Nomad

SERVICE LETTER

00-1

NOMAD FUEL SELECTOR SYSTEM RIGGING

Figure 1 Directional Flow Valve

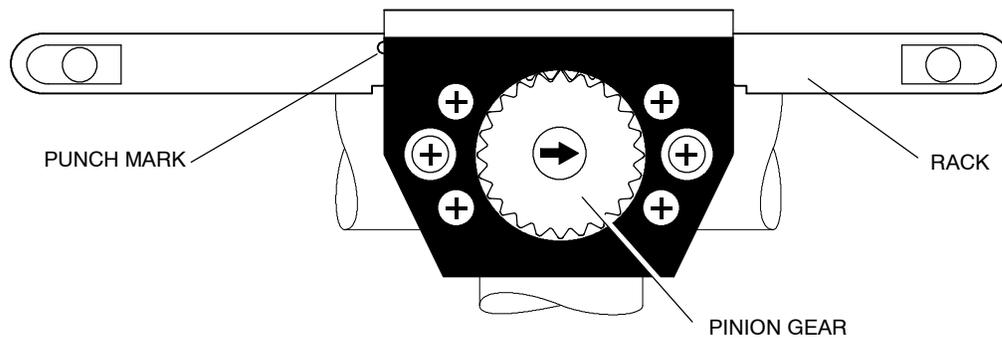
2. Incorrect indexing of the directional flow valve racks relative to the valve pinions/ports.

The small arrow visible at the centre of the directional flow valve pinion gear should point outboard towards the wing tip when the punch mark on the forward surface of the valve rack is aligned with the side of the rack housing (Ref Figure 1). The valve racks must be correctly located before inspection check 3 may be performed .

NOTE:
WHEN THE PUNCH MARK IS AT POSITION SHOWN,
ARROW MUST POINT TO WING TIP.

LOOKING AFT - LH VALVE SHOWN

2. Incorrect indexing of the fuel selector valve racks relative to the valve pinions/ports.

Remove the valve rack housing and its dust cover. Re-install these parts with the valve rack positioned as described in the inspection section of this letter.

Figure 2 Rigging - Fuel Selector System

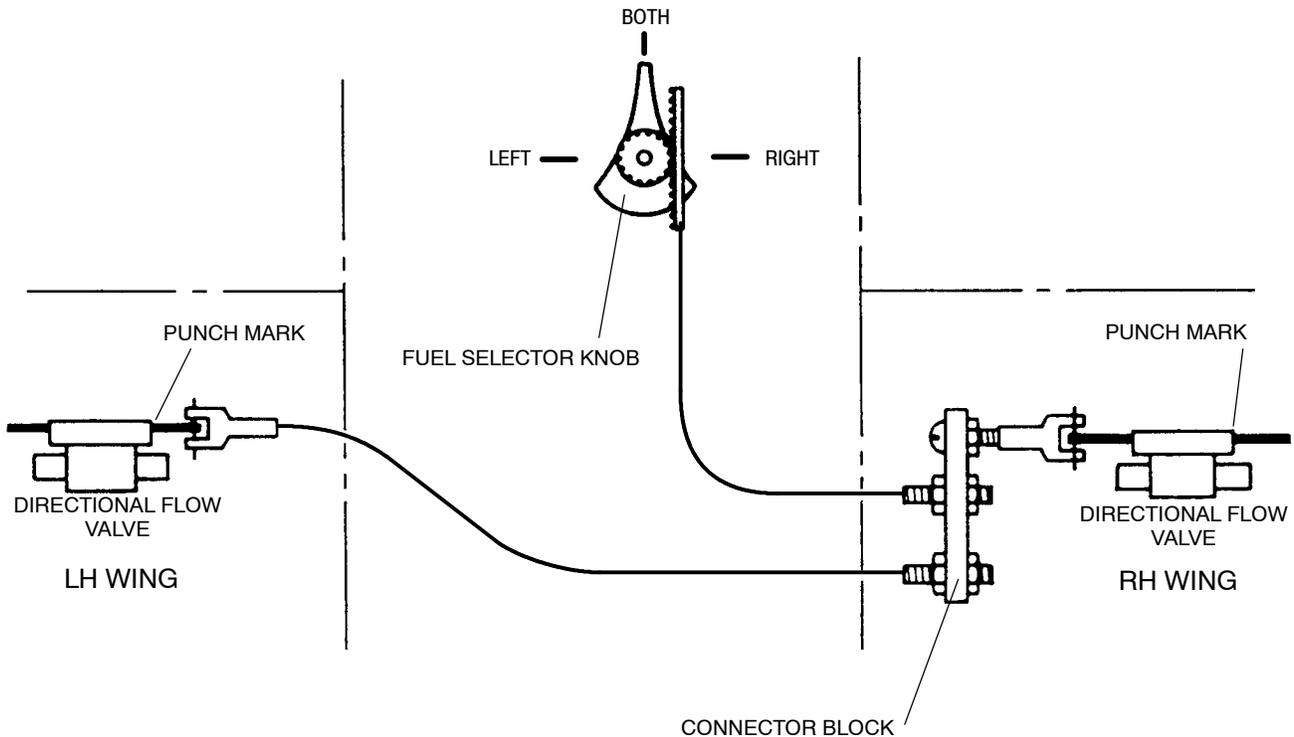
3. Misalignment of the cockpit fuel selector knob.

With the fuel selector knob in its middle detent position (Ref Figure 2), the tip of the Knob should align to within 0.25 inches of the marking adjacent to the word 'BOTH'.

4. Misalignment of the directional flow valves.

The racks of the directional flow valves should align to within 0.065 inches of their centre positions when the fuel selector knob is rotated to its middle position ('BOTH') from either the LH or RH positions (Ref Figure 2). The centre position of the valves is determined using the punch mark on the forward face of the valve rack. When the valve is centred, the punch mark aligns with the side of the valve rack housing (Ref Figure 1).

3. Misalignment of the cockpit fuel selector knob.

Locate the cockpit fuel selector knob in its middle detent position. Remove the knob and let the selector shaft drop slightly to release its pinion gear from the rack. Re-position the selector shaft so that the selector knob, when re-installed, points to within 0.25 inches of the marking adjacent to the word 'BOTH'.

4. Misalignment of the directional flow valves.

Adjust fuel selector cable ends as required to achieve the requirements of the inspection section of this letter.
